2 Type of change

Product Change Notification					OGN-SMD Cover isolation material change		
owner	creation date	release date	released by	change order no	rev	page	D10-011-082
dislercy	2016-11-23	2017-02-01	nowakfr	2011797	A	1 of 1

Old label		New label

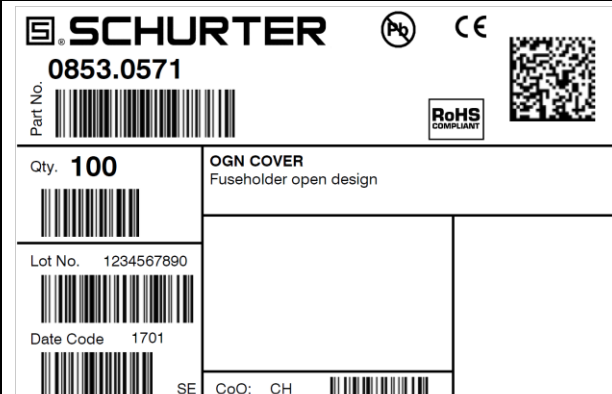
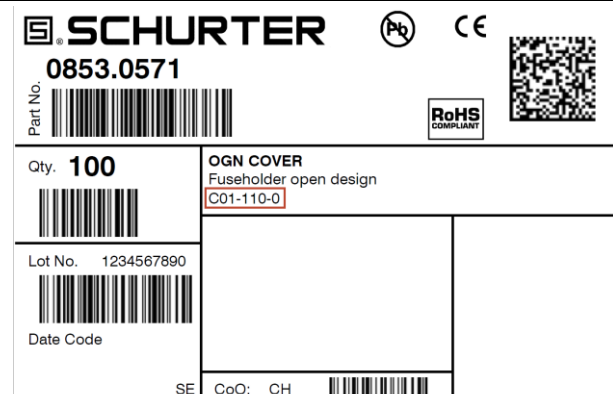
- Change of material
- Modified label

3 Detailed description of change

The new material fulfil the glow wire requirements given in IEC60127-6:2014 and is free of halogenated flame retardant and red phosphorus. The new material achieves reflow solderability acc. JEDEC JSTD020E (Moisture sensitivity level 1)
